ATTACHMENT 3

Project Number: PPR2004-00027 **Date:** August 16, 2004

Project Address: 770 E. Walnut Street

Project Description: Demolish six buildings and construct 103,000 square foot building containing 71 residential units, 3,800 square feet of first-floor commercial space, and 144 subterranean parking spaces.

Title: **Basement Upper Parking Level Plan (P1)**
 Scale: **1/8" = 1'-0"**
 Date: **10/15/2014**
 Drawing No: **Pr-5**

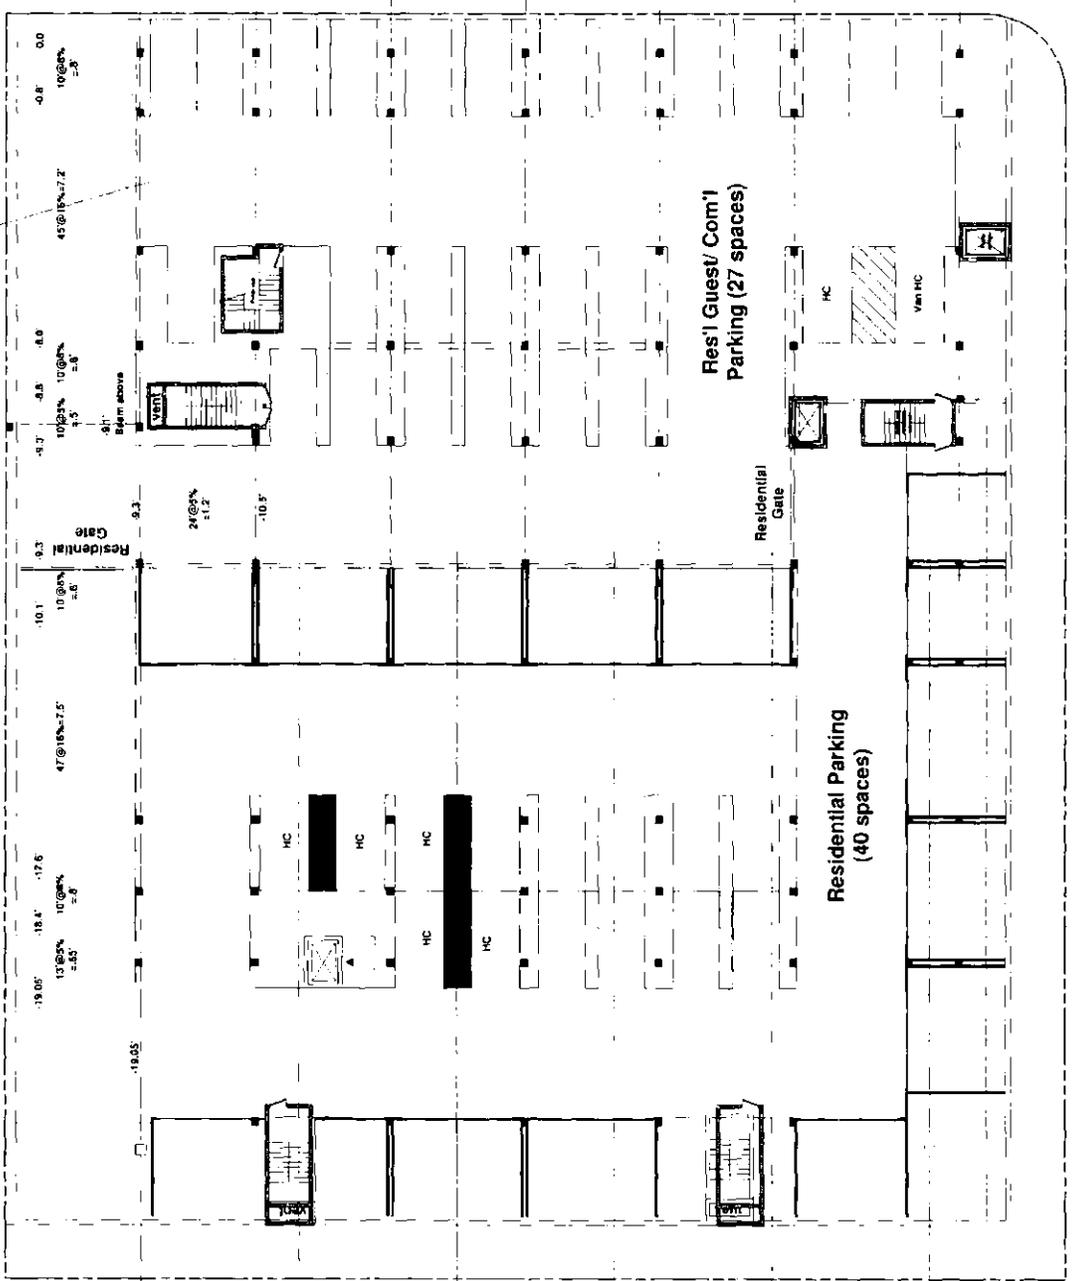
Loading: Based on the square footage of the commercial component and the types of uses indicated on the plans, the Off-street Parking Regulations of the Zoning Code requires one large loading space (12' x 34' x 14') be provided on-site for the project. The proposed first floor plan indicates that one small (10' x 20' x 10') loading space is being provided that does not meet the loading space requirement. Also, the code requires that all maneuvering of the loading spaces be done on-site and not in the public right-of-way. As proposed, vehicle movements for the loading space would have to be done along Walnut Street. Revise the plans to correct this or obtain a waiver from the Director of Transportation.

The placement of all parking in two levels of subterranean parking goes as far as the City could ask in minimizing the visual effect of parking. However, *CDSPDG* 7.2 says to "locate service, loading, and storage areas away from public streets and public spaces, as far as feasible." It is questionable whether the loading area adjacent to Walnut Street meets this guideline.

Loading: The loading as shown on the plans does not conform to the requirements of the PMC, specifically the requirement for head-in and head-out. The City may be willing to allow for an on-street loading zone on Hudson Avenue should the applicant dedicate a ten-foot strip of land on Hudson Street with the length to be determined by the Departments of Public Works and Transportation.

Pr-7
 [Redacted]
 [Redacted]
 [Redacted]

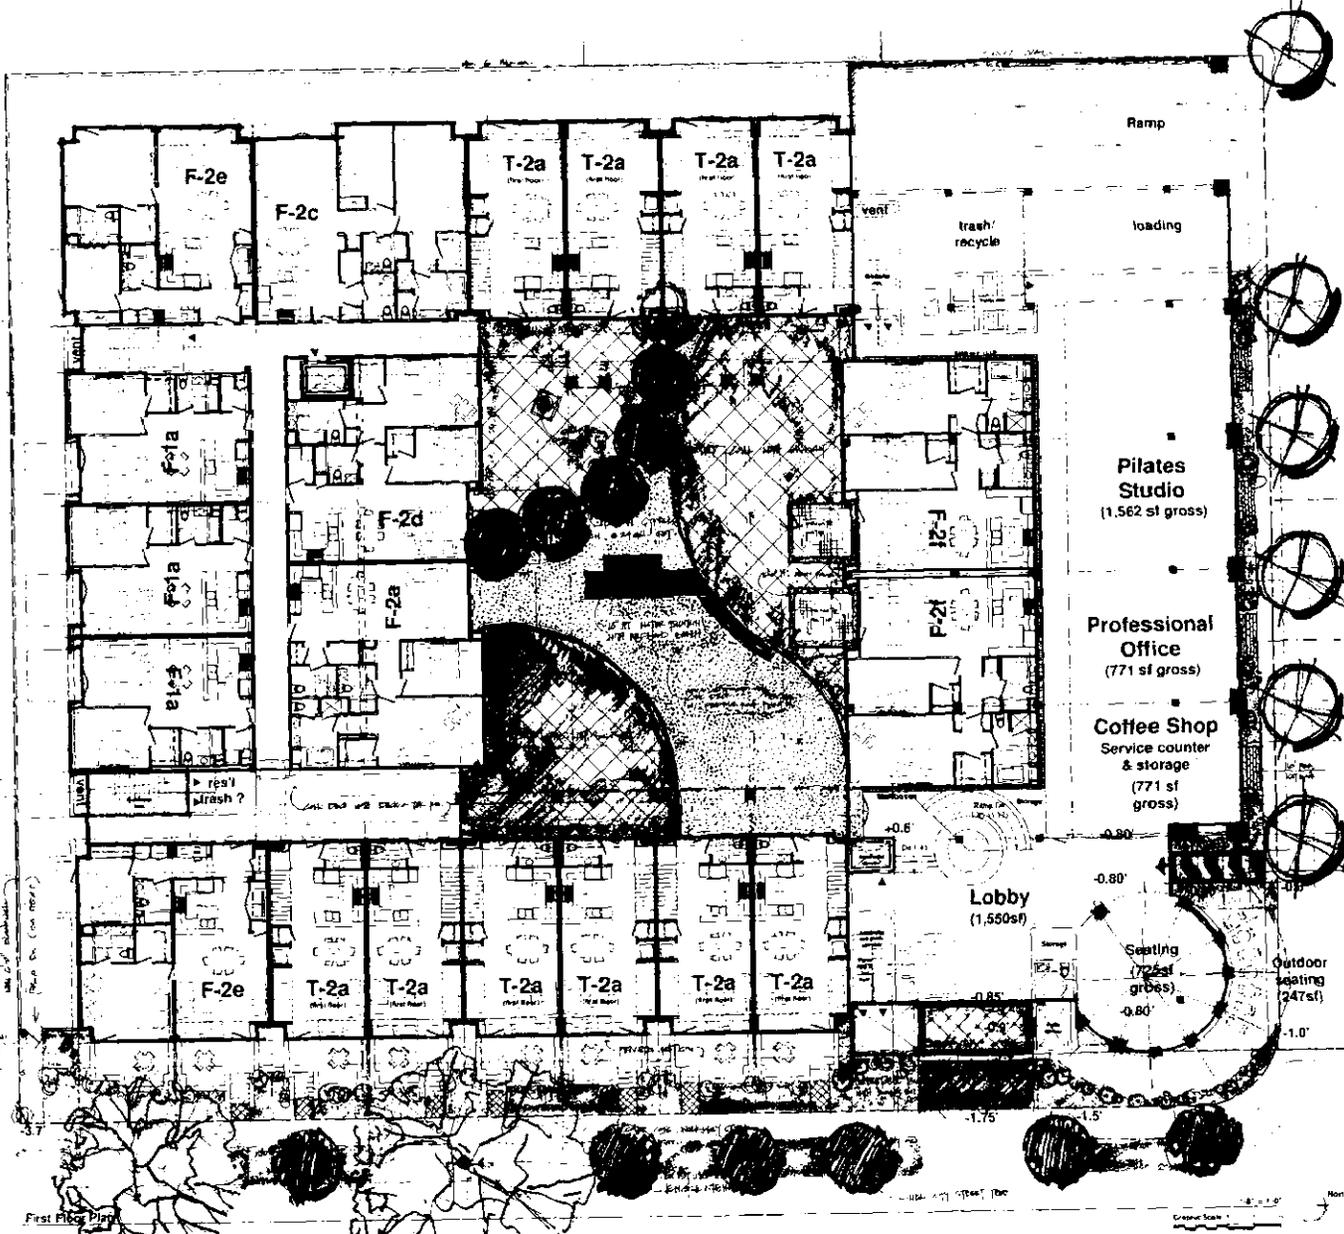
Landscaping: Two existing oak trees in the parkway along Hudson Avenue have branching that extends over 15 feet into the property. The proposed setbacks appear to accommodate these trees well. In addition a private tree in the front setback of the neighboring property to the south may be affected by the development. The applicant should have an arborist identify that tree, and, if it is a protected tree, devise a tree protection plan at the Concept Review stage for this private tree, as well as for the public trees.

The landscape plan shows six trees in the central courtyard, along with a variety of hardscape surfaces. The applicant should consider the beauty, shade and cooling powers of additional landscaping in the courtyard (*CDDG* 5.2: "encourage the use of on-site planting").
